BUILDING PERMIT REPORT

DATE: 2 APRIL 98 ADDRESS: 2110CCAN AVE. 140-E-002
REASON FOR PERMIT: To extend deck 8'-9" to 8' x 32'
BUILDING OWNER: Leonard Lawrence
CONTRACTOR: owner
PERMIT APPLICANT: SAA
USE GROUP R-3 BOCA 1996 CONSTRUCTION TYPE 5B

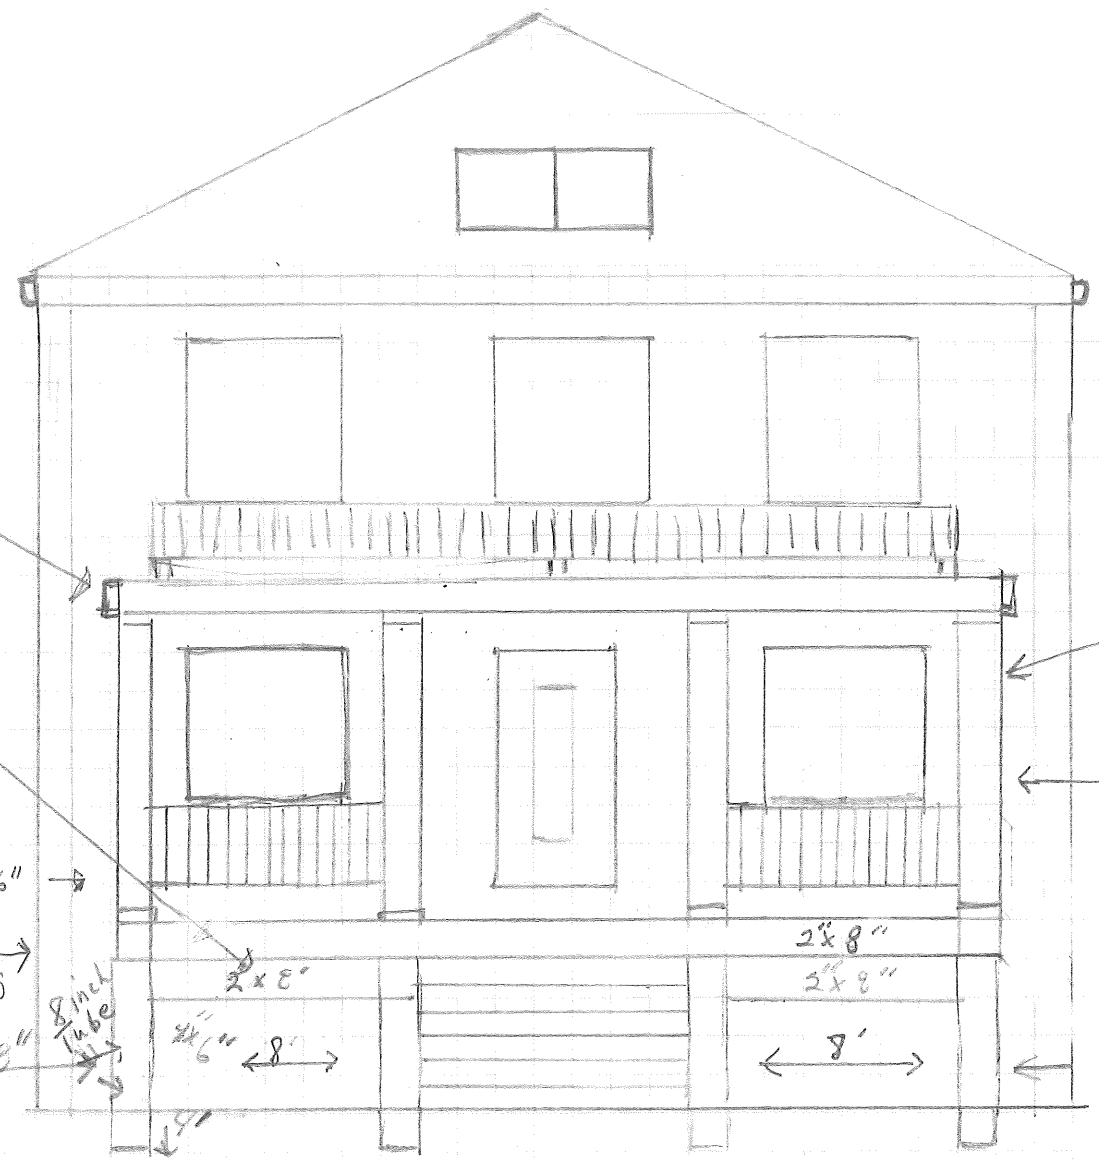
- *29. The proposed 8" Sona Tubes being used for foundation must rest and be attached to footing-
- *30. The proposed structure must be lag-bolting to the existing structure - The head must be doubled 2x8" curving

- *31. The proposed columns must be capable of carrying the weight placed upon them and arranged to transfer the live and dead loads to the foundation -

211 OCEAN AVE

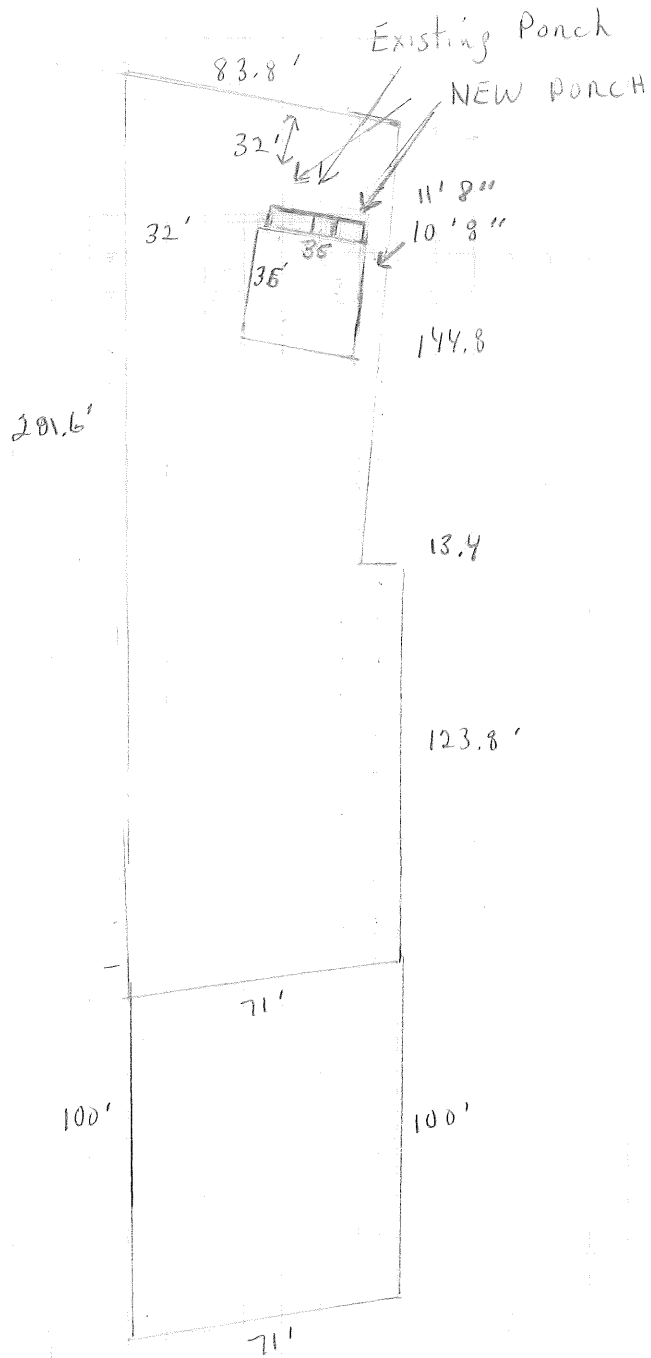
Front setback req 25' - 32'
Shown

side yard 10'8" OK
(could reduce down to 8' - 14' req, but every foot taken off needs to add on to the other side - where more than enough is shown)
